Rezoning Transportation Analysis
Petition Number: Insert Zoning Petition #2020-181
General Location Identifier: 11122105

Revision Log:

Date	Description
01-21-21	First Review (WB)
02-15-21	Second Review (WB)
04-23-21	Third Review (WB)
05-27-21	Fourth Review (WB)
09-28-21	Fifth Review (BKB)
10-13-21	Sixth Review (BKB)

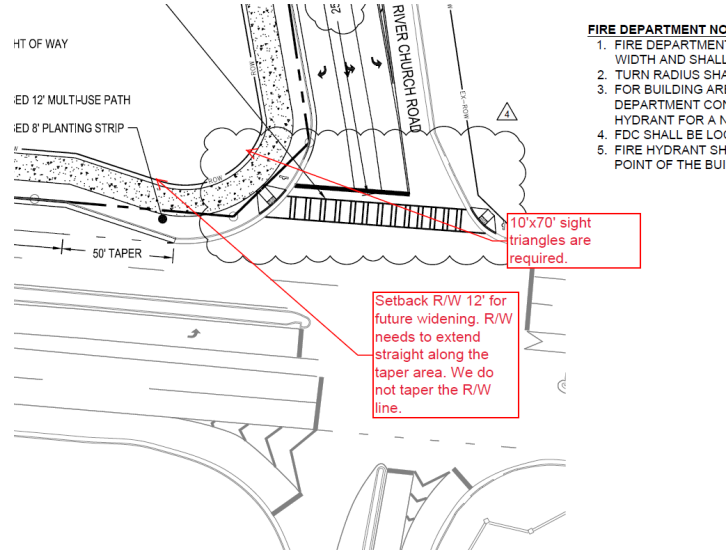
~~1. **Curblines:** The proposed zoning district has a setback measured from back of the existing or proposed future curblines.~~

~~a. **Albemarle Road:** The site plan reflects the future location of curb and gutter.~~

~~Label and dimension the curb and gutter from the centerline for each road on the site plan.~~
